SAFETY RELATED RECALL

Global Recall Action
Number: N623v2

Subject: Gasoline Fuel Tank Flange Assembly Cracking	Publication No.: N623v2
	Model: Discovery 4 / LR4 (LA)
	Model Year: 2010 - 2016
	Model: Range Rover Sport (LS)
	Model Year: 2010 - 2013
	Date of Issue: 27 June 2022

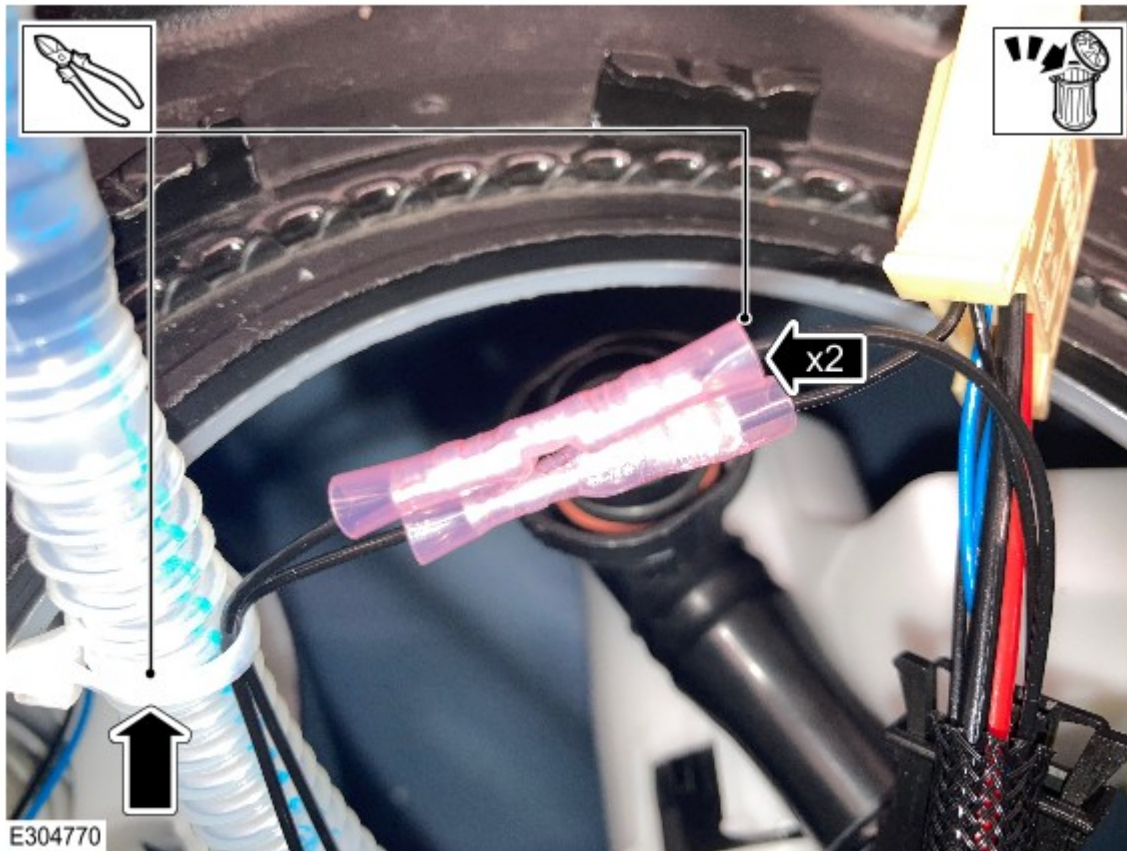
CAUTION: If the 2 splice connectors shown in the illustration are installed, they must be removed and discarded. The wires must be cut as close to the splice connectors as possible.

The instructions provided within the SERVICE INSTRUCTION section below will vary for vehicles which have previously had Technical Bulletin LTB00566 completed. Up to 3, black 2-pin electrical connectors will have previously been removed and discarded during completion of LTB00566, and instead, splice connectors will have been installed. The 2 splice connectors shown in the illustration secure the existing fuel tank flange assembly ground wires to the fuel pump driver module wiring harness. The 2 splice connectors along with the 1 cable tie also shown in the illustration will require removing and discarding to allow the existing fuel tank flange assembly to be removed and discarded.

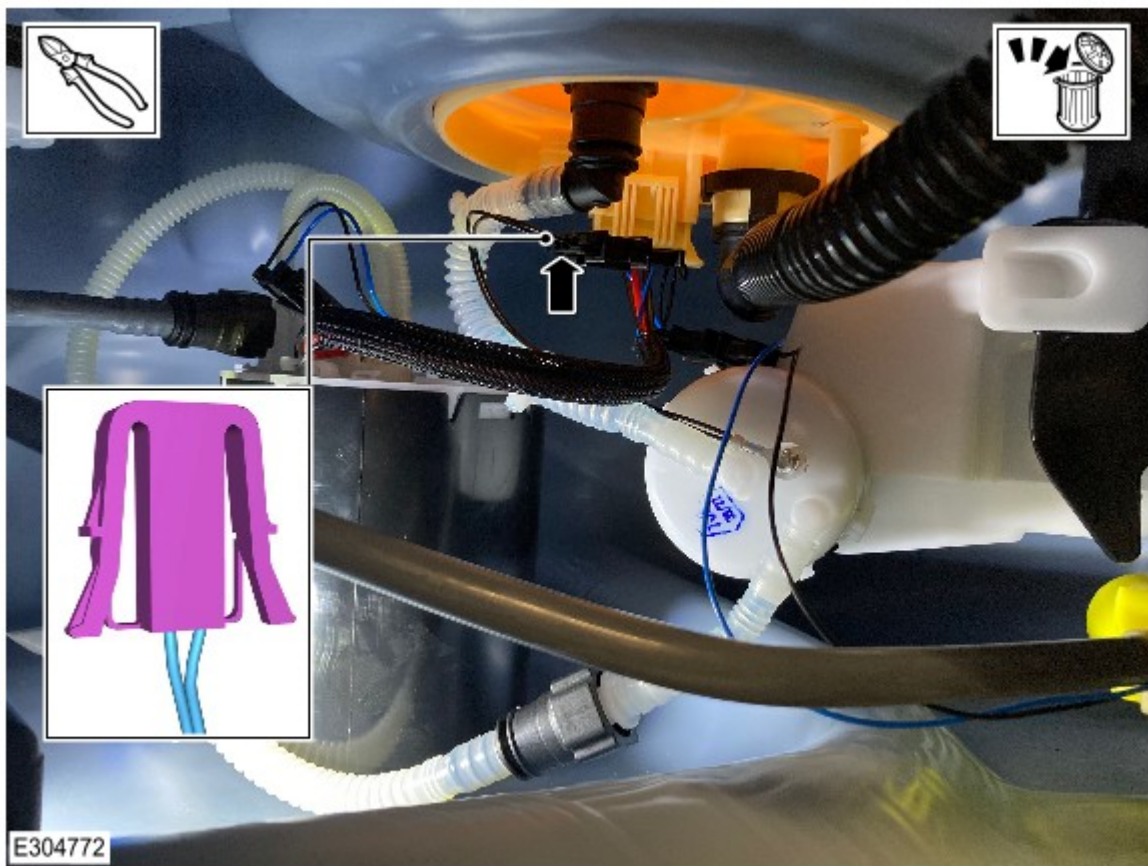
2. To install the new fuel tank flange assembly, remove and discard the male electrical connector from the new fuel filter.

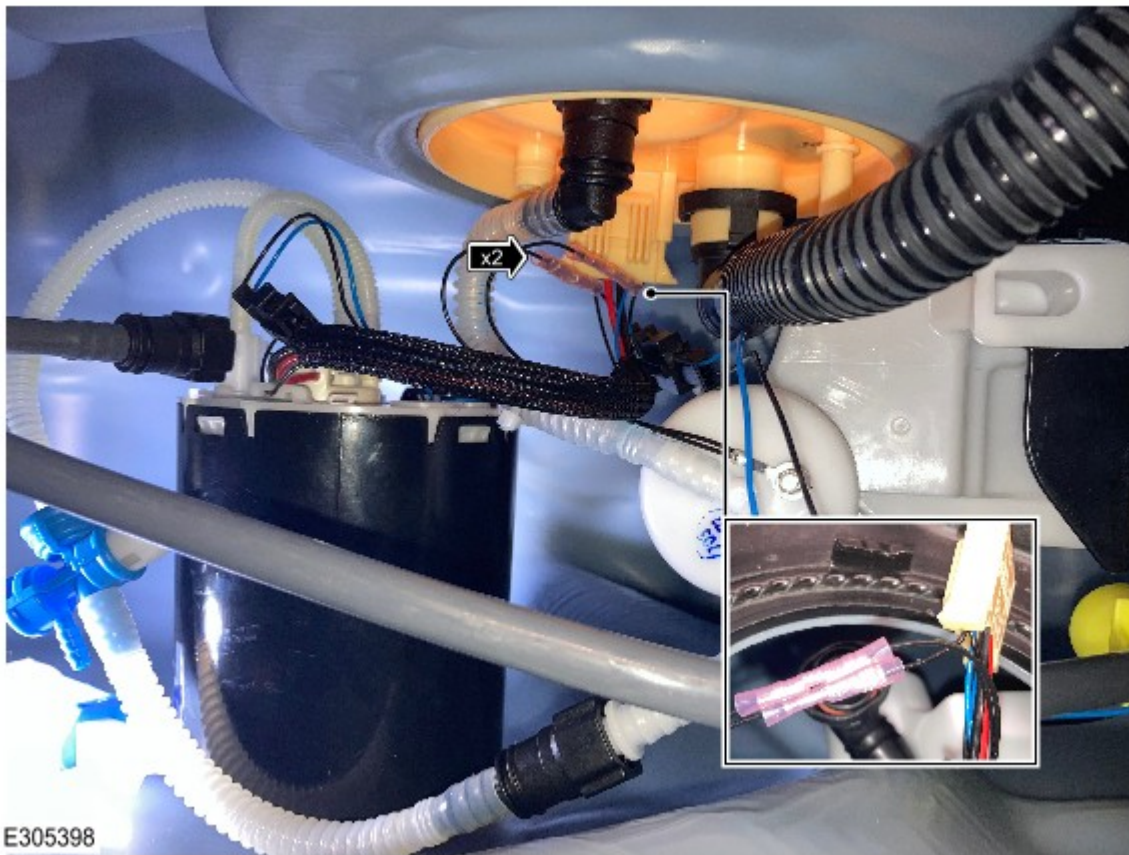
3. The 2 fuel filter ground wires must then be spliced into the fuel pump driver module wiring harness. If required, (see TOPIx Workshop Manual section 418-02: Wiring Harnesses - Description and Operation - Wiring Harness).

E279993

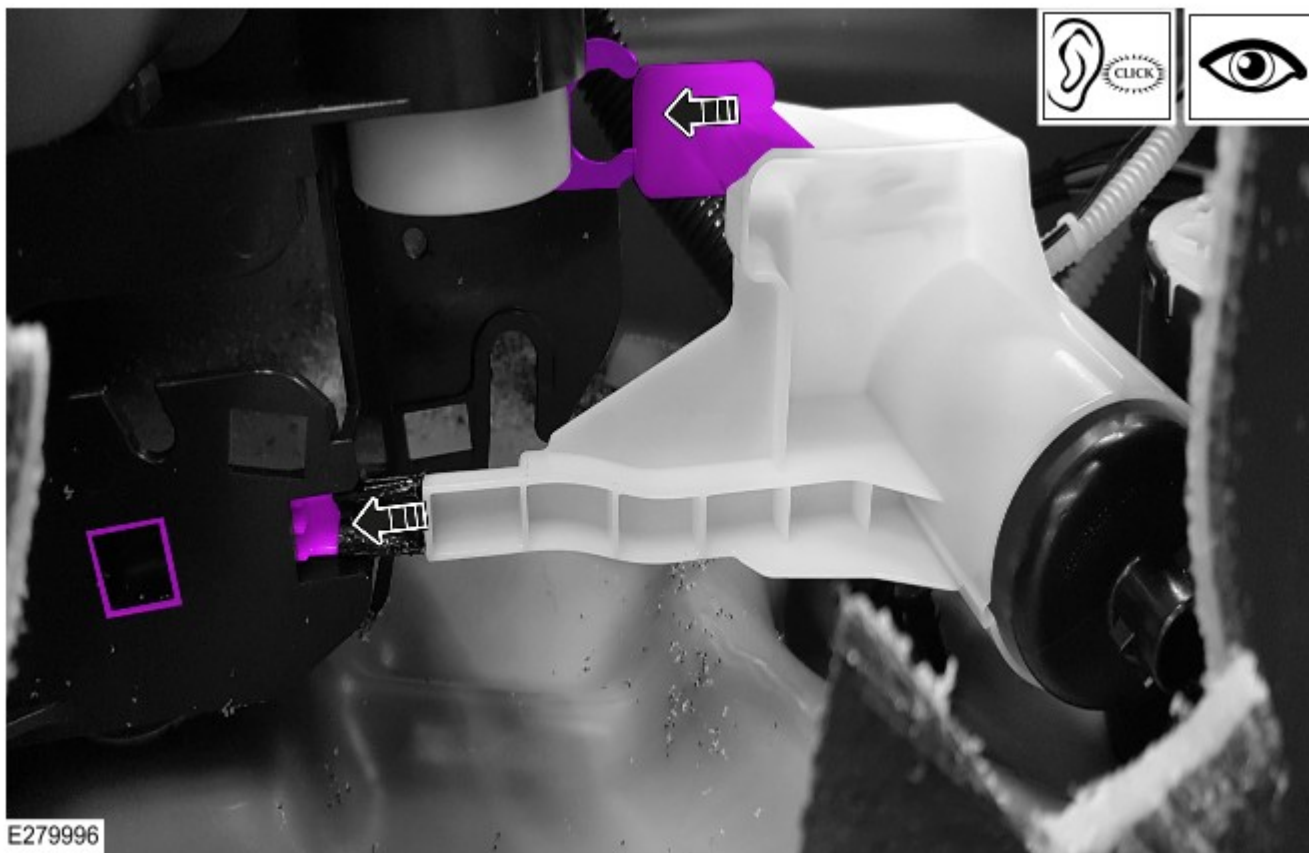
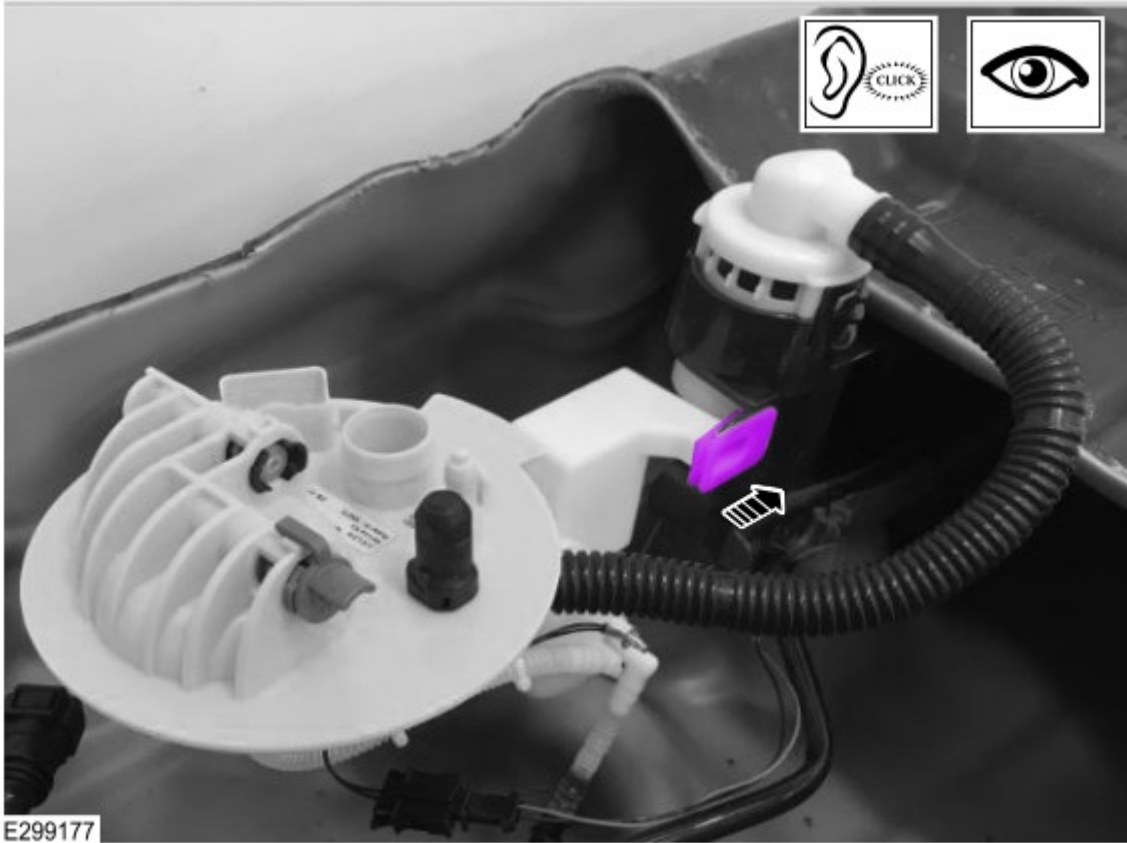
2. Install the new fuel filter into the bracket, as shown in the illustration.

3. Install the bracket and fuel filter assembly into the fuel tank, an audible click will be heard when the bracket and fuel filter assembly is correctly installed. Each illustration shows the installation from different angles.

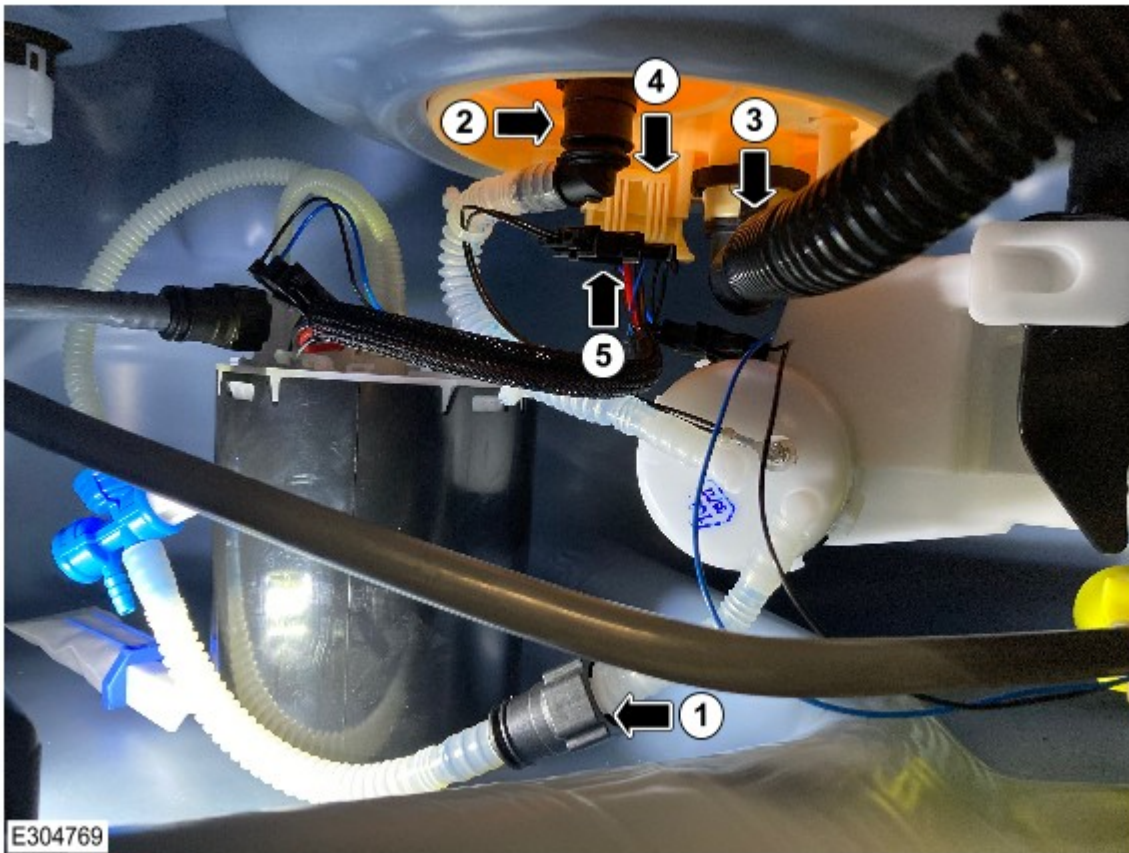
4. Connect the bracket and fuel filter assembly to the **new** fuel tank flange assembly and the existing fuel pump driver module.
 1. Connect the fuel pump driver module hose to the fuel filter hose.
 2. Connect the fuel filter hose to the new fuel tank flange assembly.
 3. Connect the vent hose.
 4. Connect the fuel tank flange electrical connector.
 5. Connect the ground electrical connector.

E299179

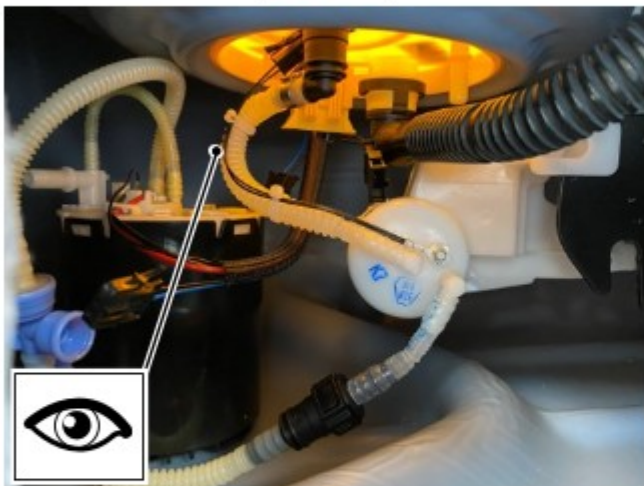
5. Make sure the fuel hose is positioned as shown, facing away from the fuel tank flange electrical connector.
